Modification of the St. Louis Class B Airspace Area; MO

ACTION: Final rule; correction.

SUMMARY: This action corrects a final rule published in the **Federal Register** on February 15, 2006 (71 FR 7848),

ST. LOUIS, MO CLASS B AIRSPACE AREA

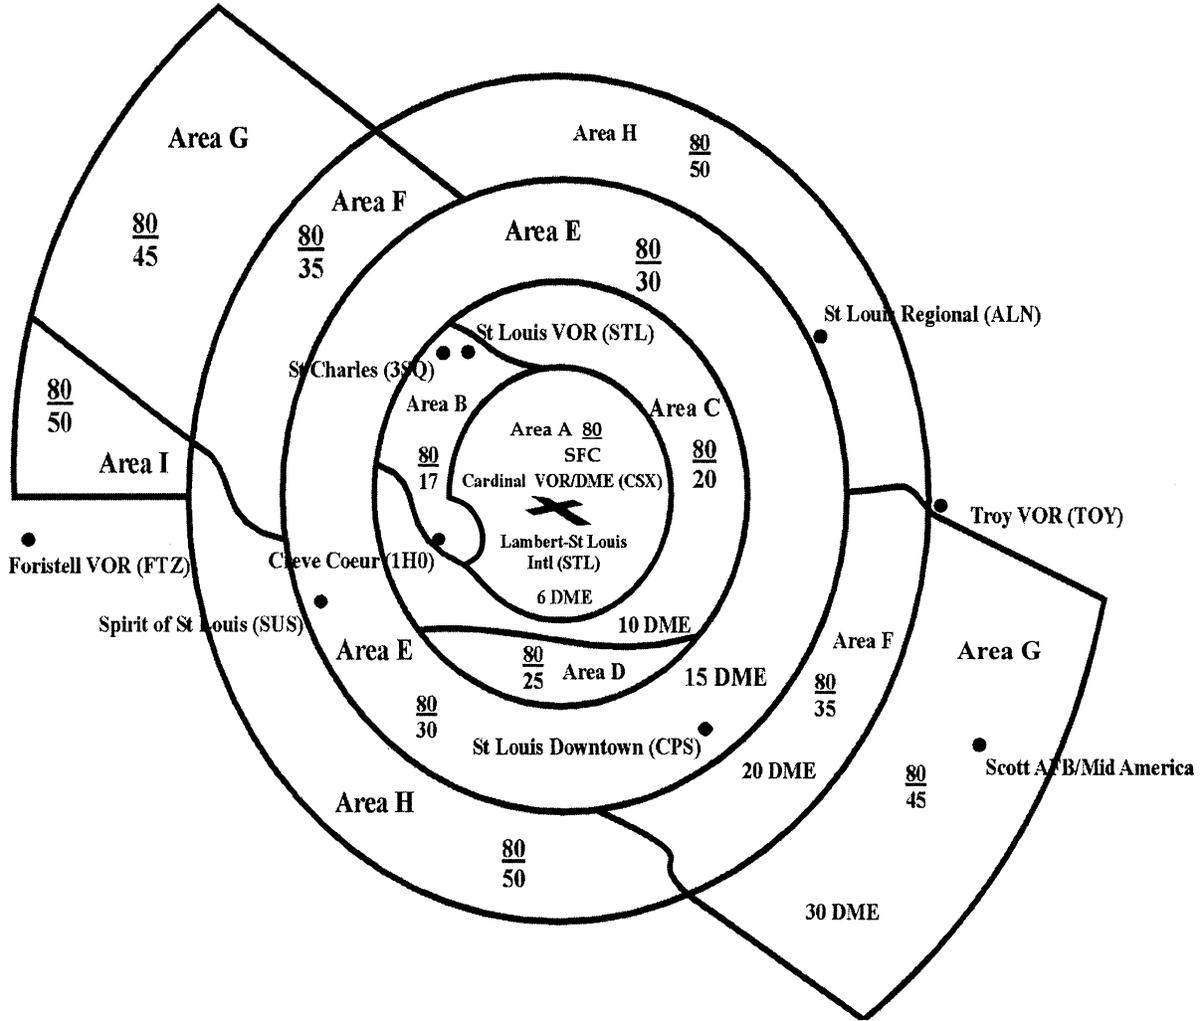
On February 15, 2006, a final rule was published in the **Federal Register** modifying the St. Louis Class B airspace area (71 FR 7848), Airspace Docket No. 03-AWA-2, FAA Docket No. FAA-2005-22509. In that final rule, inadvertent errors were made in area A of the attached graphic of the St. Louis Class B airspace area. Specifically, the altitudes for Area A were depicted as extending from the surface to and including 5,000 feet MSL (50/SFC) rather than from the surface to and

including 8,000 feet MSL (80/SFC). Also, the 1.5 NM radius exclusion around Creve Coeur Airport was not depicted. This action replaces the graphic reflecting the correct altitudes for area A and the exclusion around the Creve Coeur Airport.

■ On page 7851, Area A, delete the graphic of the St. Louis, MO Class B Airspace Area, and insert the corrected graphic.
